City of Edina: 54th Street Reconstruction and Arden Park Area Stormwater Plan

Draft Design Stakeholder Feedback

23 October-3 November 2013

EAST Description and Cross-Section A

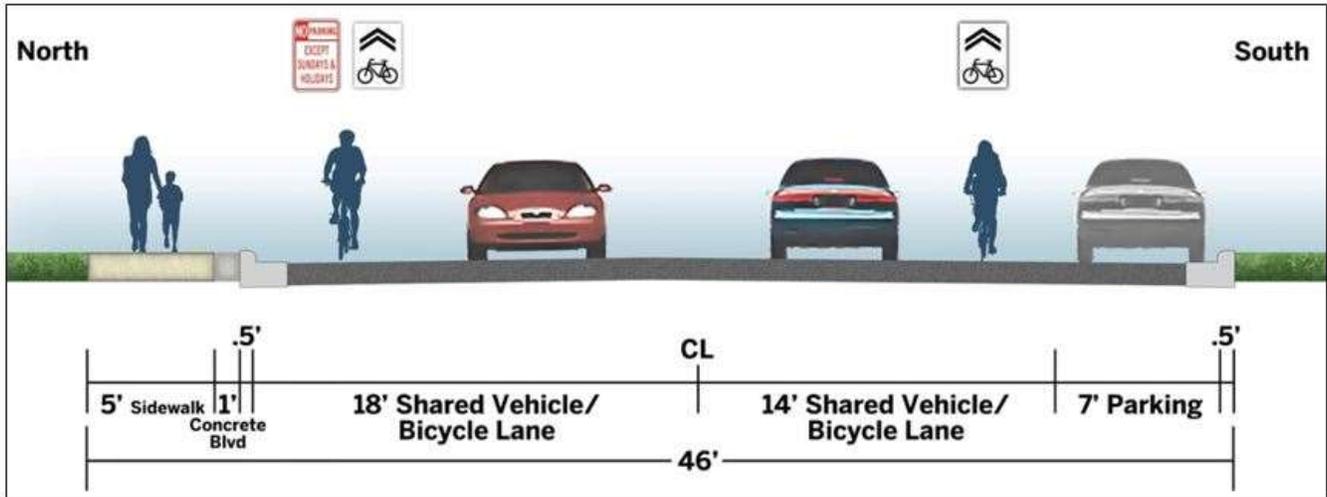
- way too wide
- Section A effectively moves problem traffic speeds and noise pollution traffic 4' closer to my dining room/family room and will have an exclusive adverse impact on our property value, quality of life, and safety of our property.

EAST Description and Cross-Section B

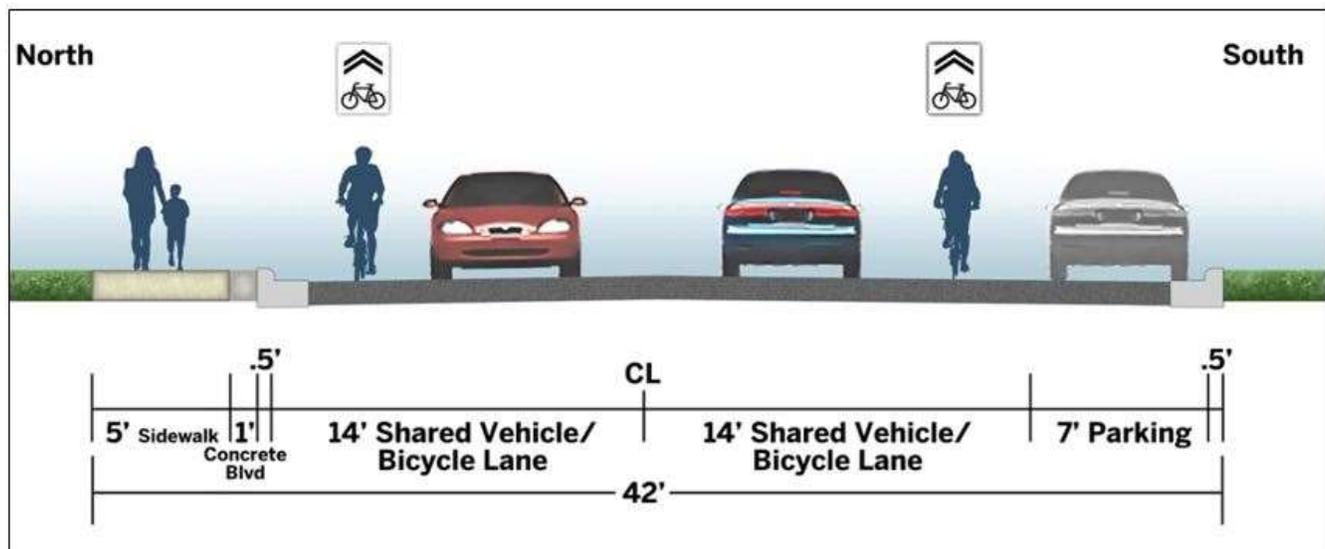
- looks good
- More appealing if parking is on both sides 7 days/week.
- Nice, shared use.
- Section B looks to me moving in a more reasonable direction
- sidewalk

- don't need parking
- It's concerning the Section B was WITHHELD FROM PRESENTATION at last night's preliminary proposal meeting. Clearly ALL resident tax payers would have far greater support for Section B implementation consistency to the creek.

MIDDLE Description and Cross-Section

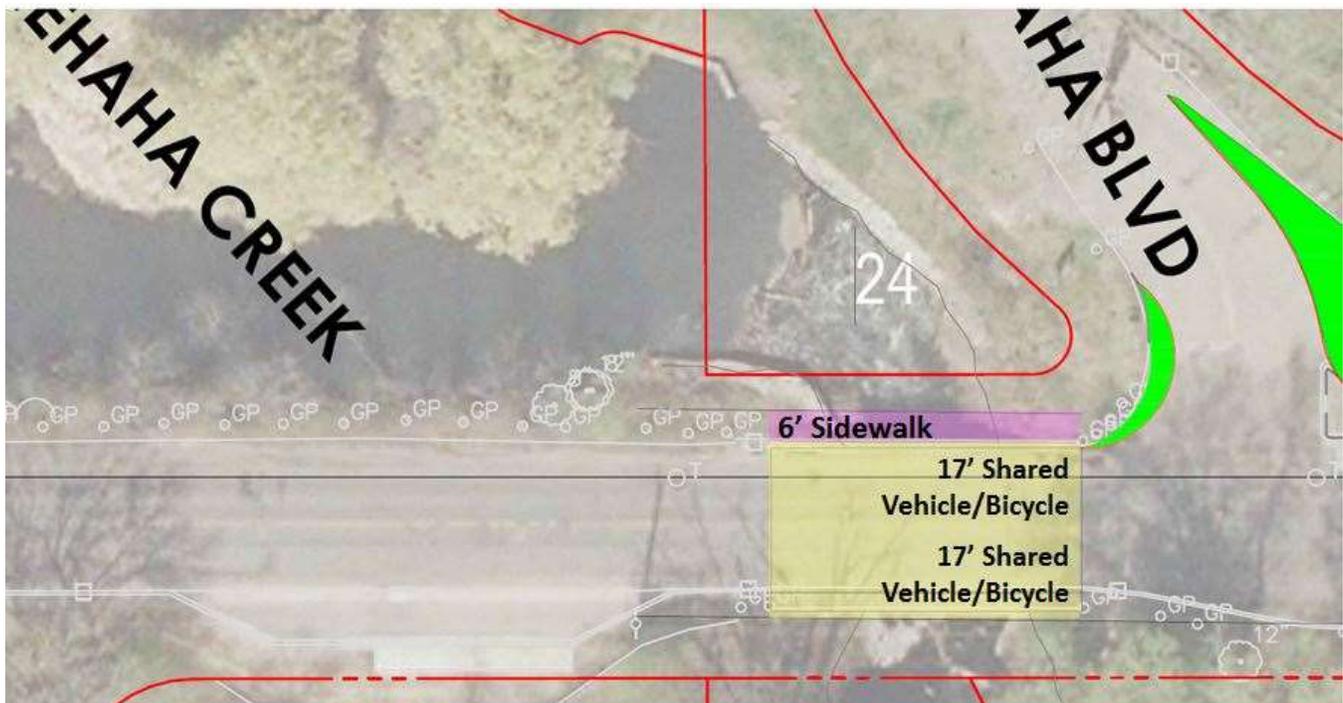
- Why increase from 14' on the east side back up to 17'? That is NOT consistent with the west side. We don't want a wider bridge! What are the future bridge needs you mention? Why on earth does sidewalk increase to 6' when 5' is perfectly fine? What is width of side walls? They add significant amount to the overall width of the bridge. I would keep a railing system so creek can be viewed by motorists AND bicyclists as they are going by. The 41' dimension you use is VERY misleading because it doesn't even take into account the decorative knee wall/railing thickness

- New design will disrupt the kayak surfing wave.
- Too wide. 17' lane is not necessary and should not continue to be forced upon the residents who pay taxes in this community.

- Too wide....can we not cut down on the width of the bridge to keep it quaint and fit into the neighborhood
- Where is the sidewalk on the south side? People like to be able to enjoy BOTH sides of bridge.

- It is unfortunate that we are calling these 'shared bike lane' when in fact the road is being widened to an extent that designates the bike lanes.
- there's room for two dedicated bike lanes 6' 11' 11' 6'

- design lacks detail
- Keep stop sign please!
- Why increase shared lane to 17' when it is 14' further down the road? Keep it simple!
- Put sidewalks on both sides of the bridge – no widening required

- 2nd sidewalk No! No!
- 17'? Why so wide?
- Narrow streets!
- I would drive faster if the road was wider...
- Proven fact that wider roads equal faster cars

- Way too wide! Sidewalk needs to be on both sides of bridge. 17' much too wide for a shared lane!
- Raising the bridge is not well thought out. Kayakers and canoeists just are not a large enough population that occupies this area. Where have they been since the very first neighborhood meeting? That would change the character of the neighborhood for the worst.

WEST Description and Cross-Section

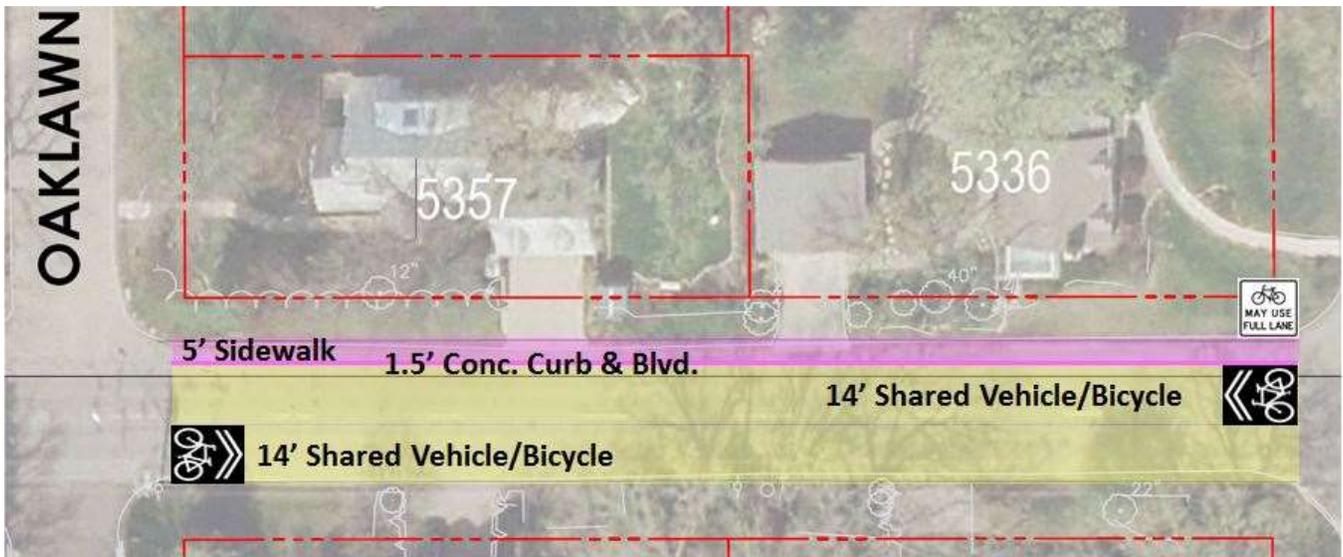
- Would be very happy if we could get west design to 34'. Thank you
- Width
- Still could be narrower overall; 1 foot concrete rumble boulevard does not need to make the overall sidewalk 6' wide...the 1 foot boulevard should be included in the overall 5' sidewalk...still appropriate for City snow removal equipment for City maintained sidewalks

- Concrete boulevard/"glorified sidewalk extension" adds unnecessary width to the project; keep 5' sidewalk and just incorporate a 6"-12" rumble strip within the 5' overall width; still meets ADA requirements; a wheelchair only needs 5' to turn around; 35' is still too wide! We want to be as close to the existing 32'+/- width we currently have...adding an additional 12" of concrete is just not a luxury we can afford here. France/Wooddale Avenues' sidewalks are currently 5'.

- 14' is still too wide for the road. Need to control speeding by having narrow lanes
- 6' bike, 10', 10' + 2' = 28
- Where will the signage go and we need to keep that to a minimum

- Still too wide. Interesting that the 1' detectable warning strip is ADA recommended NOT required, which is how it was represented at meeting.
- The North side is required to take the lion's share of the overall change in width...there has to be a more equitable way to share this with the South side

- design lacks detail; 14' lanes
- Is the overall 35' width centered along the 60' right-of-way? It isn't, therefore the north side bears the brunt of excess

- Road is too wide – retain current width for safety and ambience
- Where is the proof that 14' is required vs. suggested?
- 34.5' still too wide – does not appear to be centered on right of way

- 14' still too wide. Our understanding that variance allows 11'
- Street too wide
- Narrow streets!
- Can this be done at 32' no wider
- These are larger dimensions than minimum

- Don't need 1' concrete boulevard
- 4' sidewalk
- 32' total width
- Street still too wide – keep current width
- Would like to see proof of state-aid regulation for MN street width of 14'. 11' is plenty of space!
